**UK Comments on the various documents under agenda item 2.4.
(Regulation No. 46: Devices for indirect vision)**

TRANS/WP.29/GRSG/2006/12

View of the road with Mirrors fitted according to Reg. 46.02

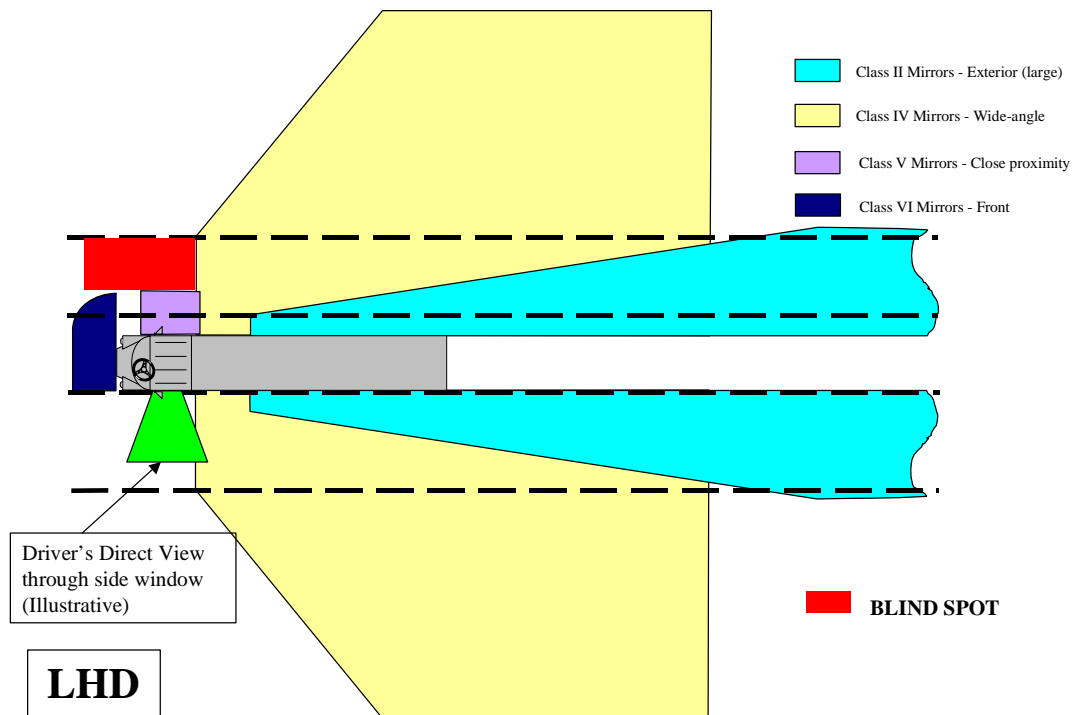
The UK believes that there are some aspects of the Japanese document that are worthy of further consideration, particularly with regards to extending the field of vision around the passenger side of the cab of heavy goods vehicles (HGVs).

The UK have observed that on HGVs with a high cab there is a blind spot alongside the cab on the passenger side of the vehicle, beyond the field of view in the Class V (close proximity) mirror. This area can be critical on a dual carriageway, when the driver of an HGV may not see a smaller vehicle alongside, and may attempt to pull over into that lane, resulting in what is commonly known as a "sideswipe" accident, when the sides the vehicles make contact with each other (see diagram below).

The UK believes that some action should be taken to address this blind spot, either by direct or indirect vision, and that the Japanese document is one possible approach.

The UK would be interested to hear the views of other delegations concerning this blind spot, and whether they support the need for some action.
